# ADDENDUM NO. 1

**March 18, 2022**

**WESTCHESTER INTERMEDIATE SCHOOL ADDITIONS  
AND RENOVATIONS  
Chesterton, IN 46304**

This Addendum consists of Pages ADD 1-1 through ADD 1-4 and attached Addendum No. 1 from Gibraltar Design dated March 16, 2022 and consisting of 4 pages, Specification Section 08 71 00 - Door Hardware, and 48 drawings.

**UNIT "H" PLUMBING TUNNEL DEMOLITION PLAN**  
SCALE: 1/8" = 1'-0"

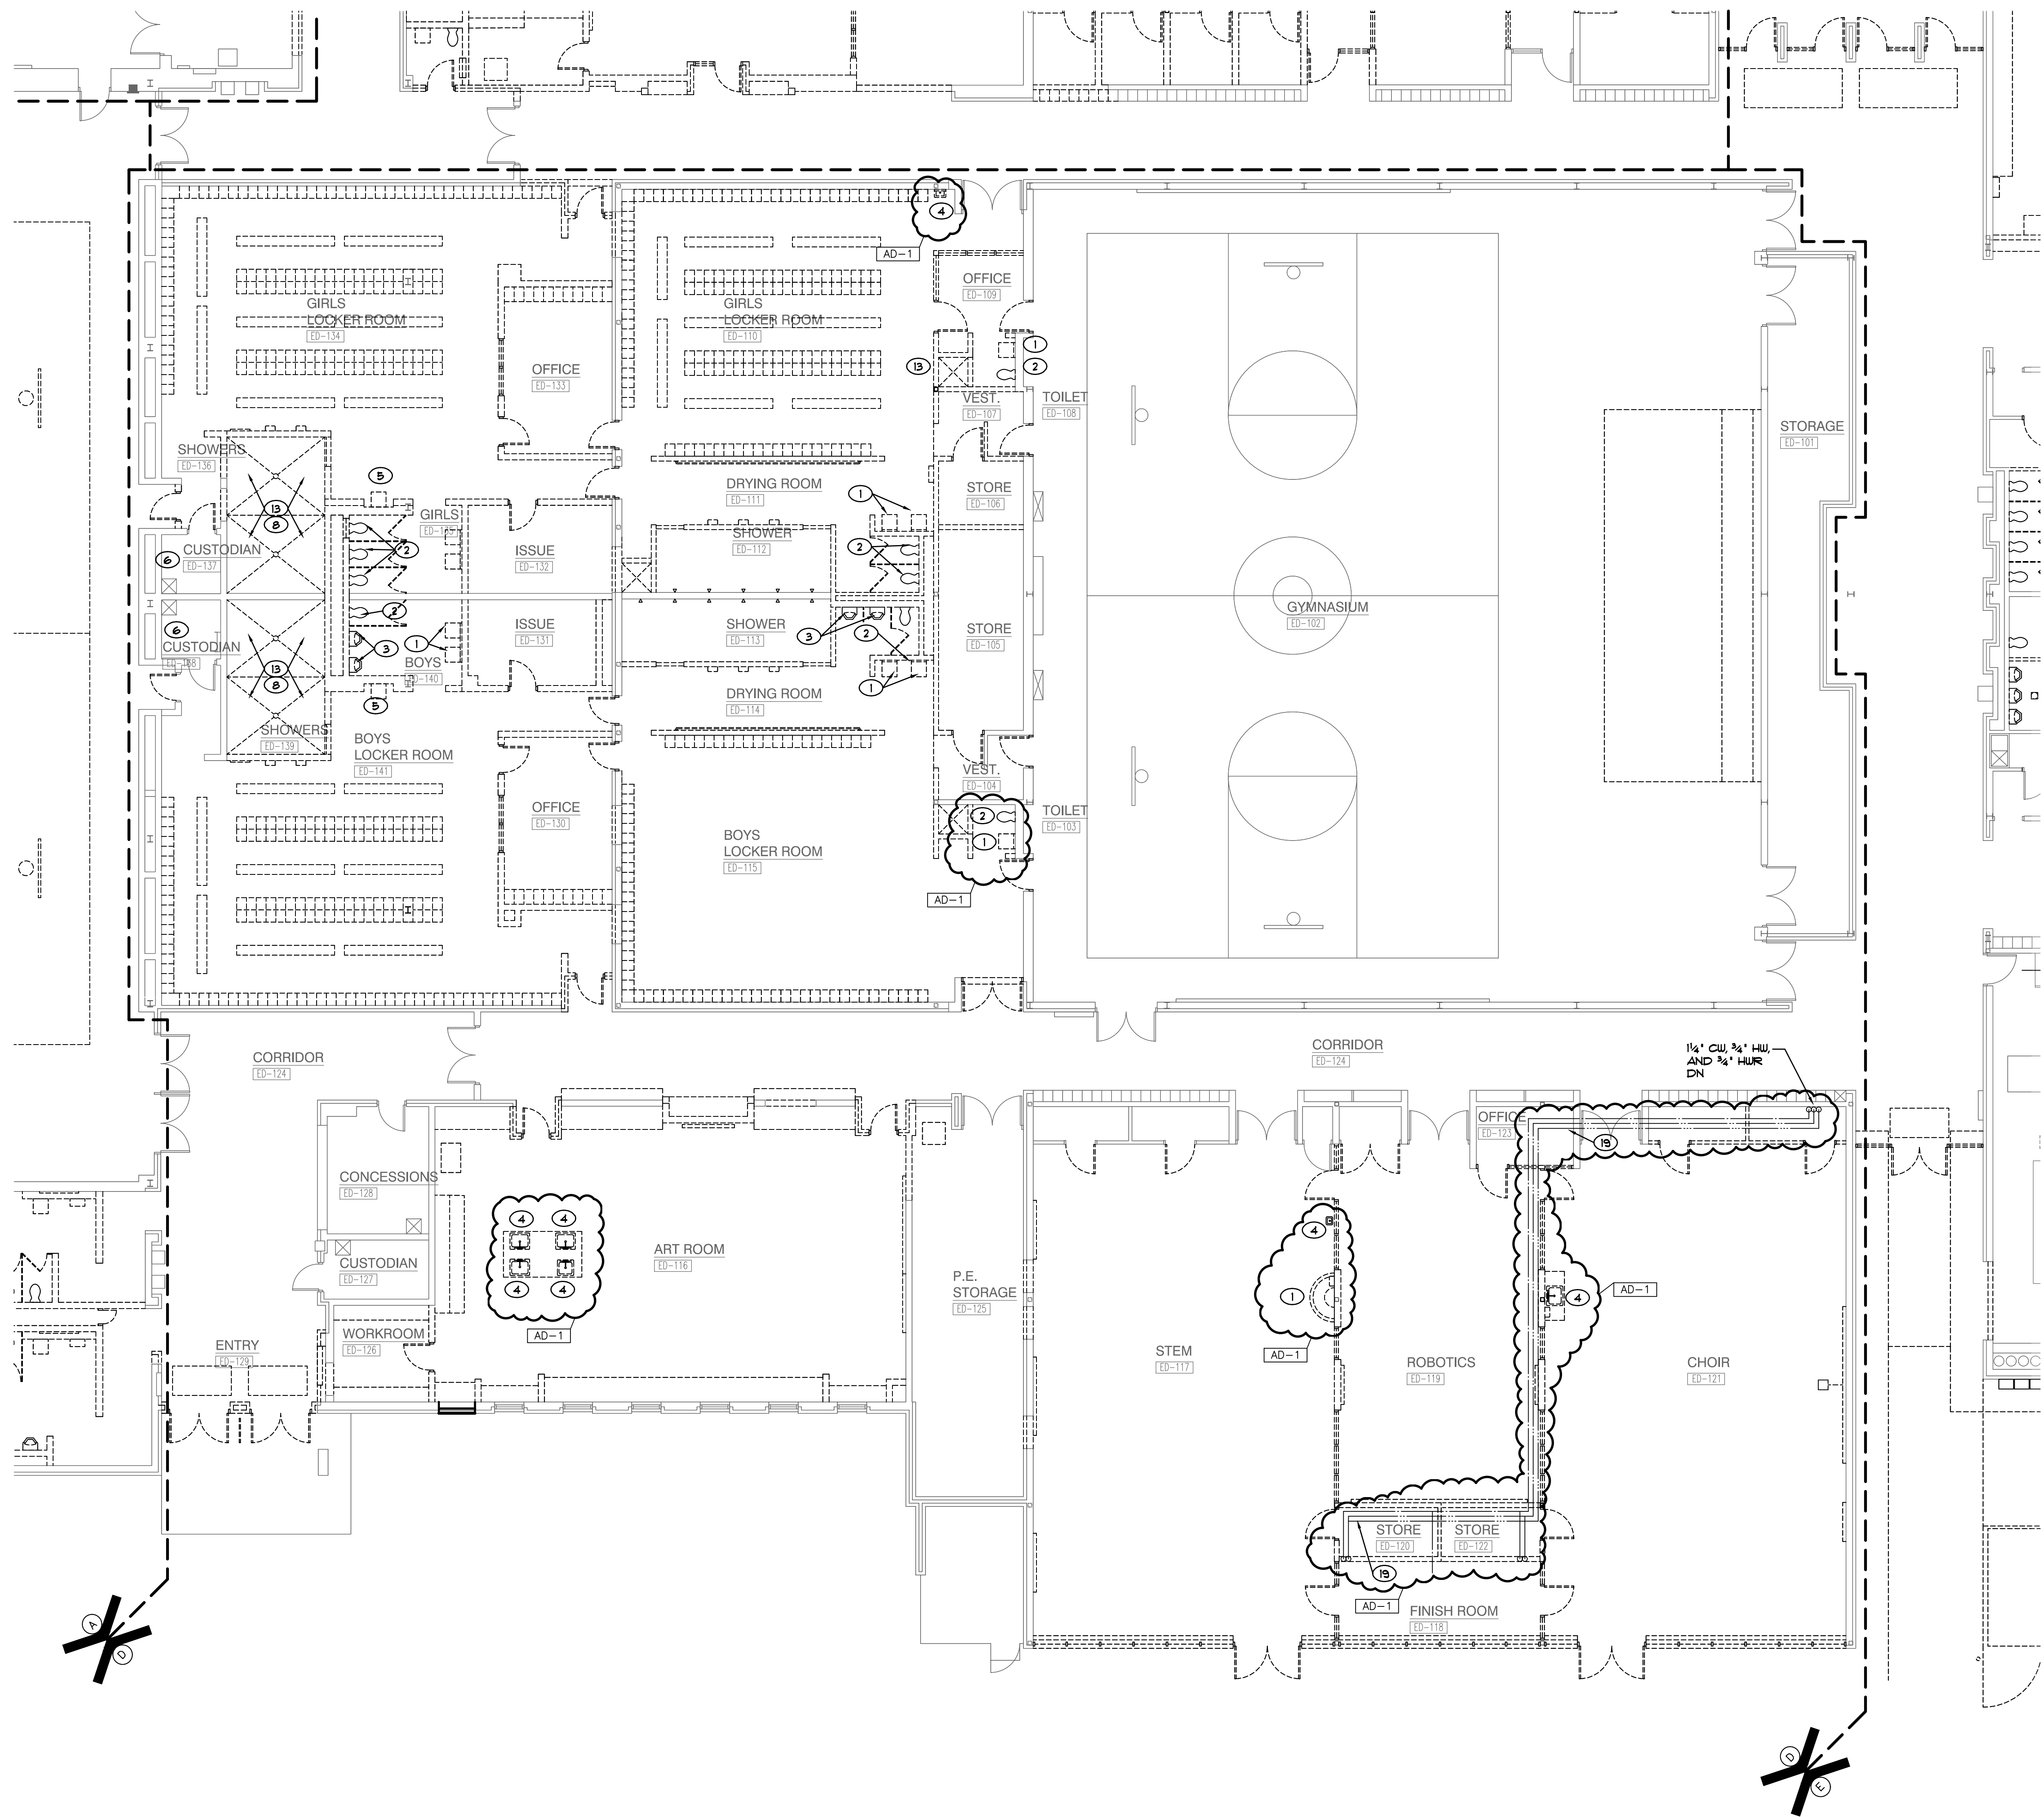
**20. Sheet PD005**

- A. Refer to revised, full-size drawing included in this Addendum, for note added to existing piping.

PD103

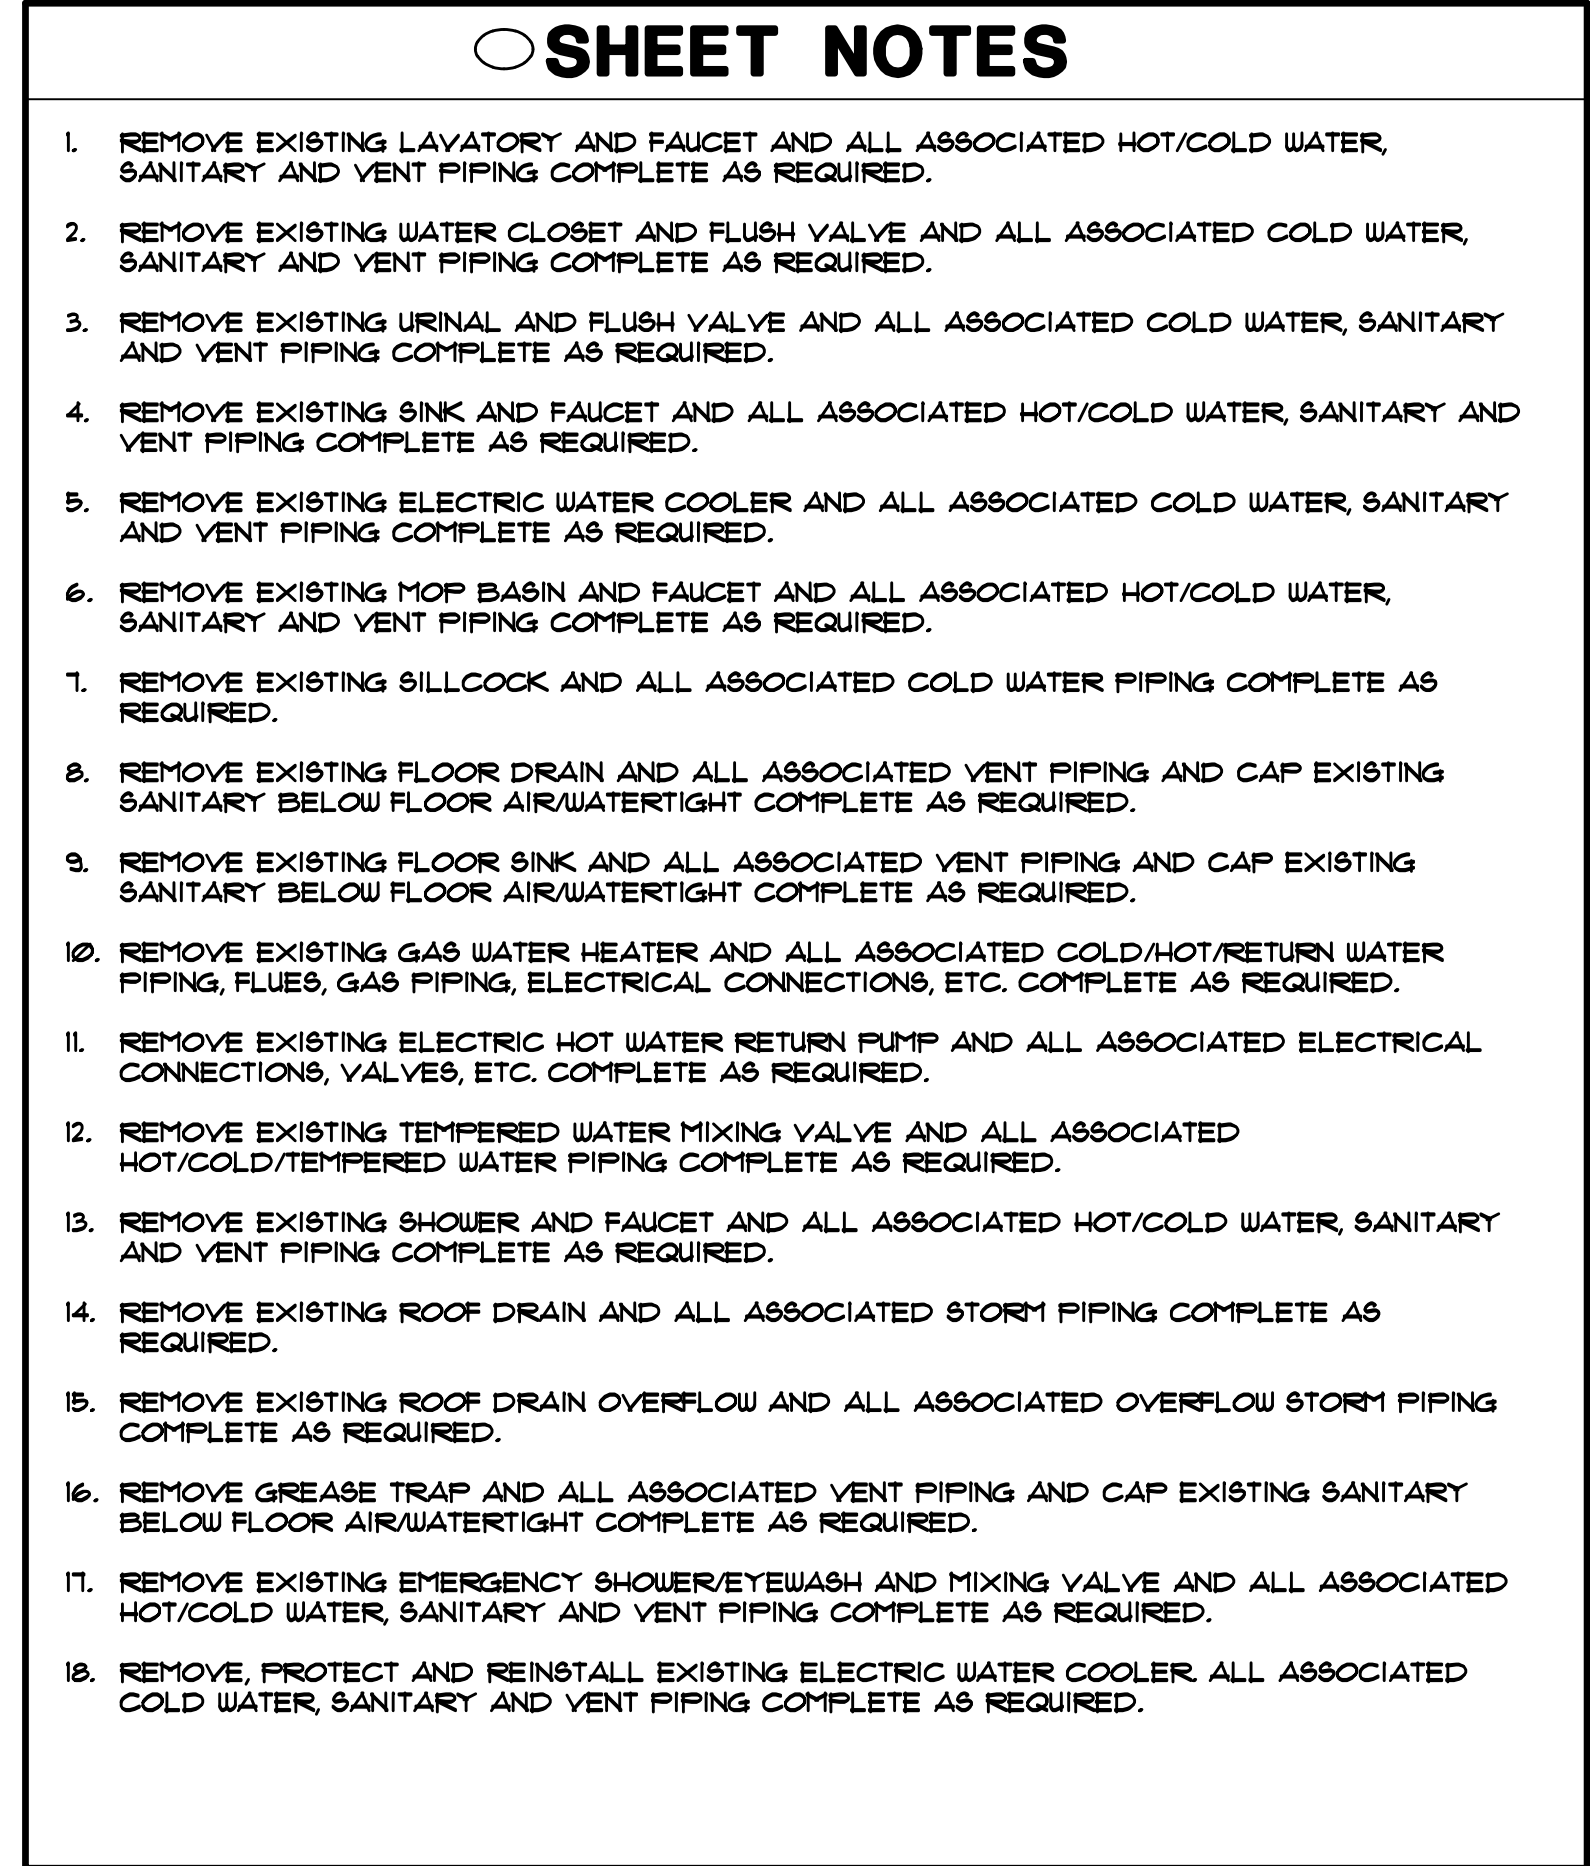
**17. Sheet PD103**

- A. Refer to revised, full-size drawing included in this Addendum, for the following revisions:
  - 1. Added Note 4 to sinks in Art Room ED-116.
  - 2. Added Notes 1 and 4 to fixtures in STEM ED-117.
  - 3. Added Note 4 to sink in Choir ED-121.
  - 4. Added Sheet Note 19 and showed existing piping.
  - 5. Added Note 1 and 2 to fixtures in Toilet ED-103.
  - 6. Added Note 4 to sink in Girls Locker Room ED-110.

UNIT "F" ELECTRICAL FIRST FLOOR LIGHTING PLAN  
SCALE: 1/8" = 1'-0"

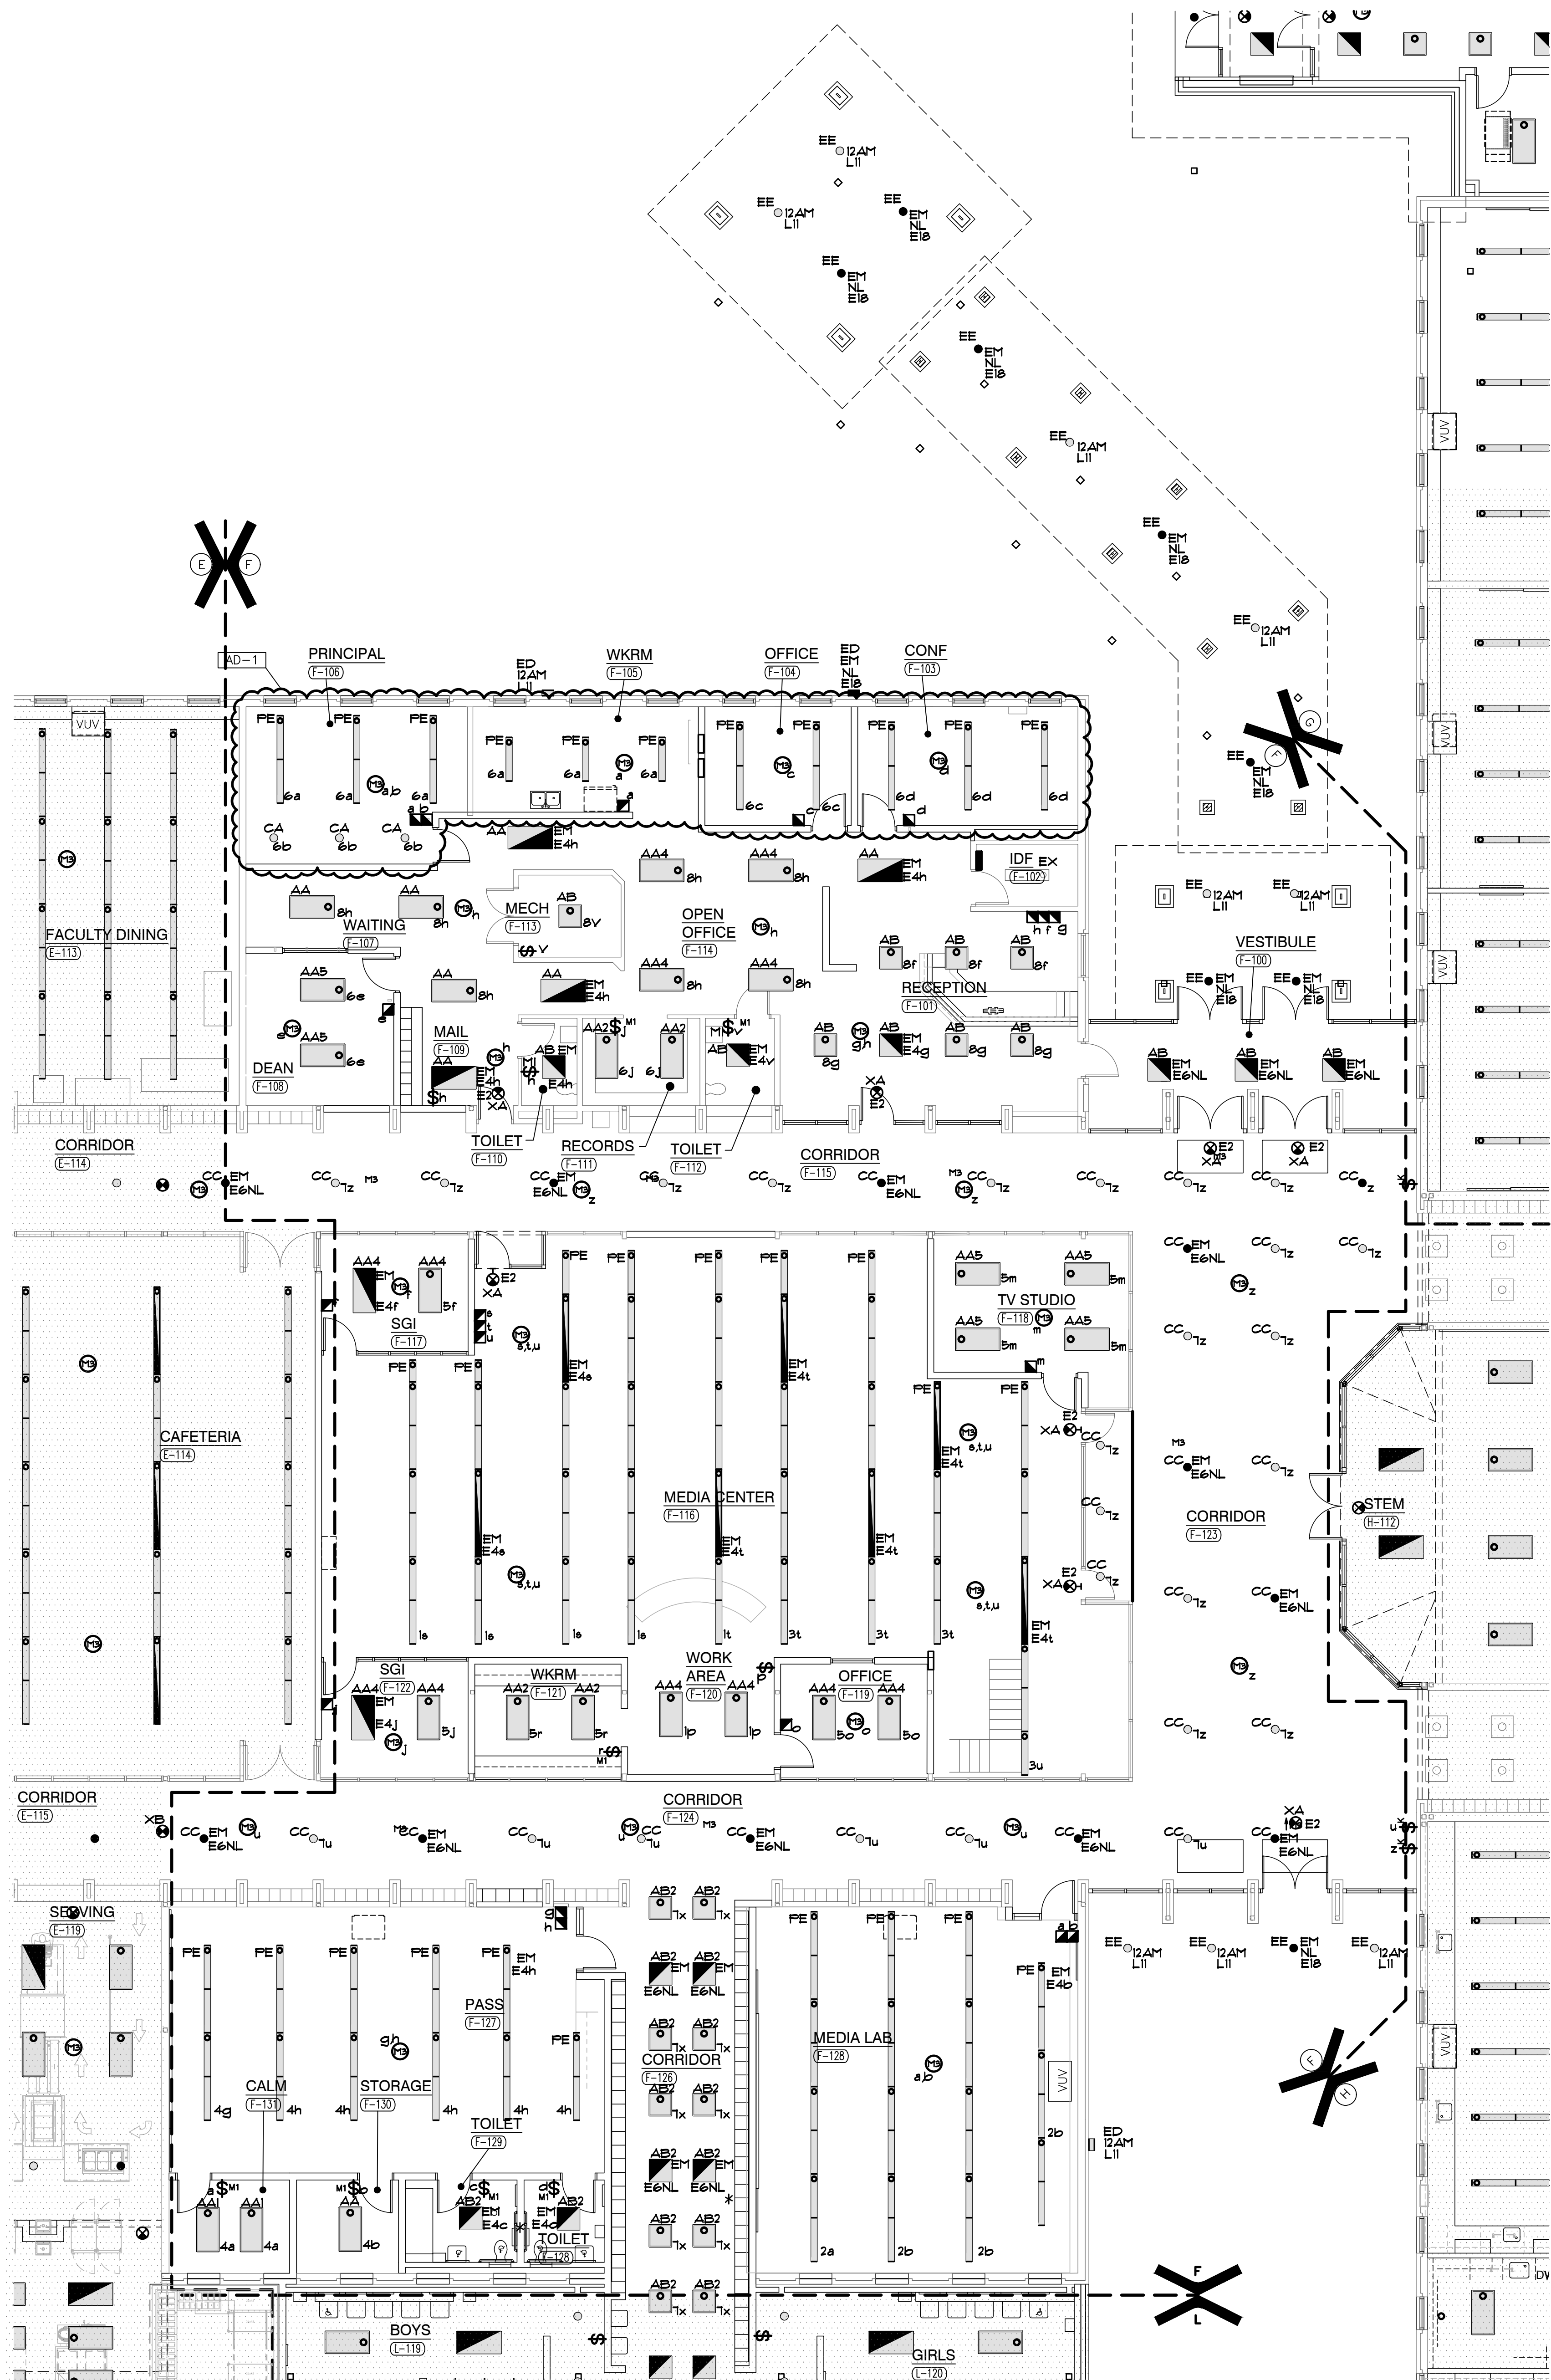
**26. Sheet EL-105**

- A. Refer to revised, full-size drawing included in this Addendum, for lighting revised in Rooms F-103, F-104, F-105 and F-106 from recessed to pendant style fixtures.
